**PROJECT: A206-16012: GMIA Ground Transportation Lot and Restroom**

**SUBJECT: Amendment 1 to Request for Proposal (RFP)**

Sanitary and Water Utilities Near Cab Lot

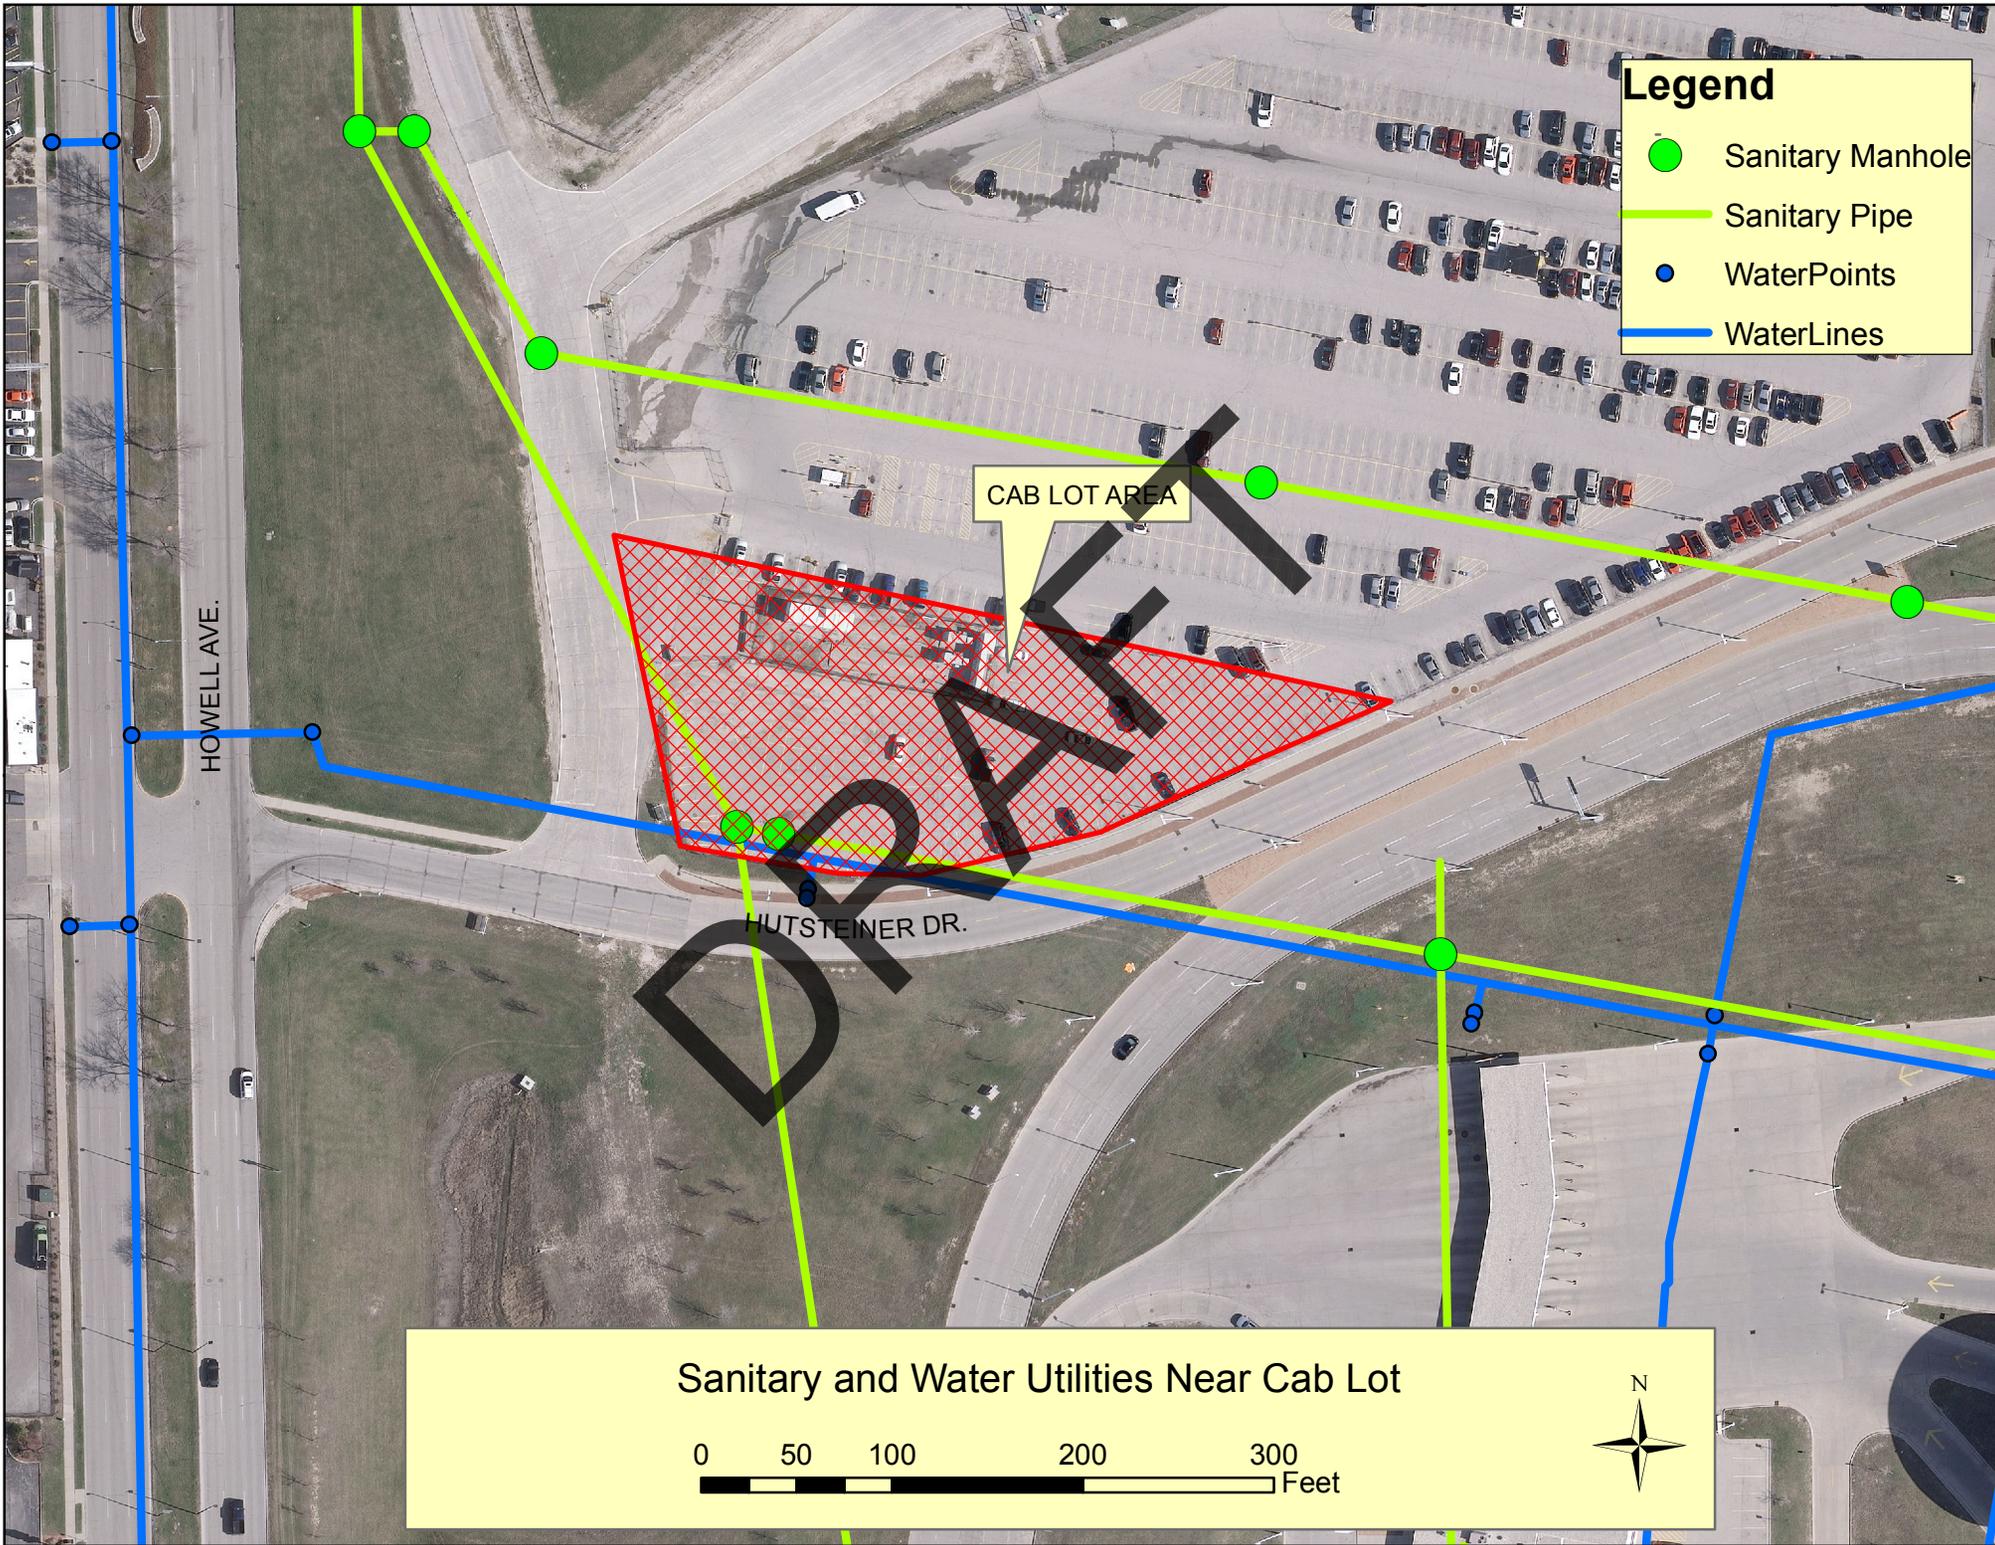
4. Please describe availability and location of potential utility connections: water, sanitary sewer, power, security, communications, etc.
  - a. See attached plans for a rough idea of connections available. The consultant is to verify all utility connections. There is water, sanitary, power, security and communications in the project vicinity.

11. The RFP notes GMIA will provide surveying needs. Is a survey available for viewing by consultants with location of utilities – sewer, water, gas, power etc ?
  - a. There is no survey completed yet. Our surveyor can pick up utilities and other items requested by the consultant. See attached plans for a rough idea of connections available.
